EQUIPMENT/FURNISHINGS - SEAT BELT BRACKET INSPECTION

Cessna Aircraft Company wishes to update the seat belt bracket for airplanes in the field to the latest design.

SEB-25-03
Page 1 of 4

Figure 1. Seat Belt Bracket Inspection (Sheet 1)

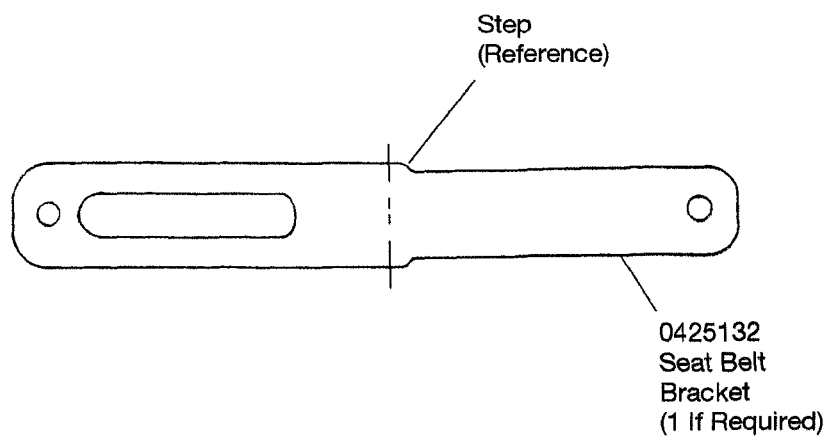
1. (Refer to Figure 1.) Do the visual inspection of the seat belt bracket to make sure that the latest type of seat belt bracket is installed as follows:

- A. If there is a step on the seat belt bracket, go to Step 2.
 - B. If there is no step on the seat belt bracket, do as follows:
 - (1) Prepare the airplane for maintenance.

- (2) Remove the seat belts from the seat belt bracket.
 - (3) Remove and discard the seat belt bracket. Keep the serviceable attachment hardware.
 - (4) Install the new 0425132 Seat Belt Bracket with the kept attachment hardware.
